STAFF REPORT: DECEMBER 13, 2023 MEETING

APPLICATION NUMBER: HDC2023-00139

ADDRESS: 19245 PARKSIDE

SCOPE: REPLACE ORIGINAL WINDOWS WITH VINYL WINDOWS, REHABILITATE EXTERIOR (WORK COMPLETED WITHOUT APPROVAL)

South-side and partial rear elevations

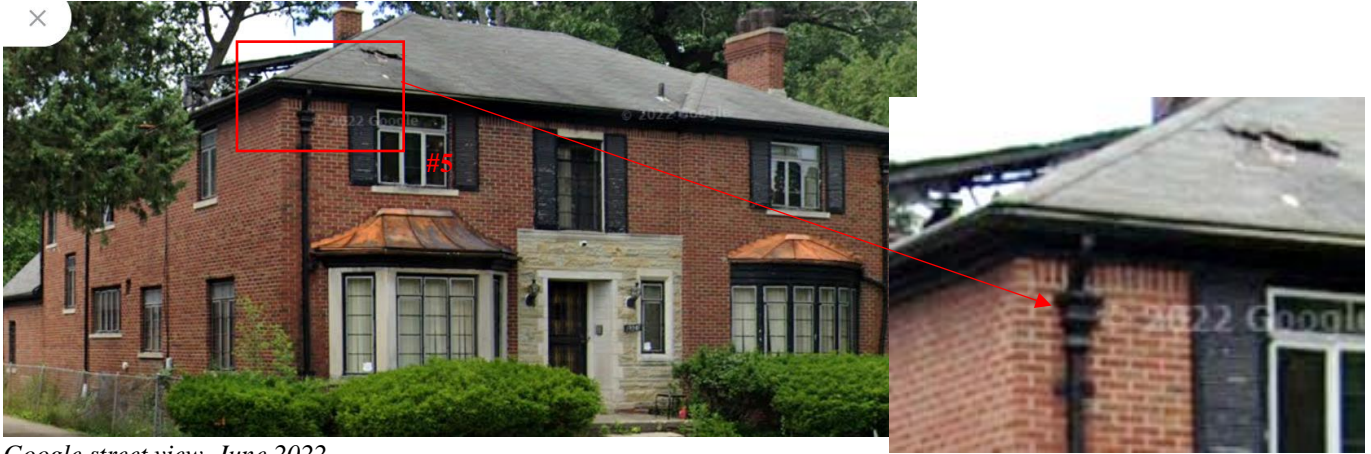
Applicant photo. Based on the masonry design of this rear corner, staff believes the upper area was possibly an open porch originally, and the lower area was possibly a screened enclosure. The vinyl window units within the first floor openings appear to be newer than the siding enclosure; the 2018 image on the preceding page shows vinyl units and the enclosed openings were in place at that time. Staff doesn't have earlier photo documentation of this area, but enclosures of porches in the 1950s-1980s were very common, so it is possible these enclosures pre-date district designation.
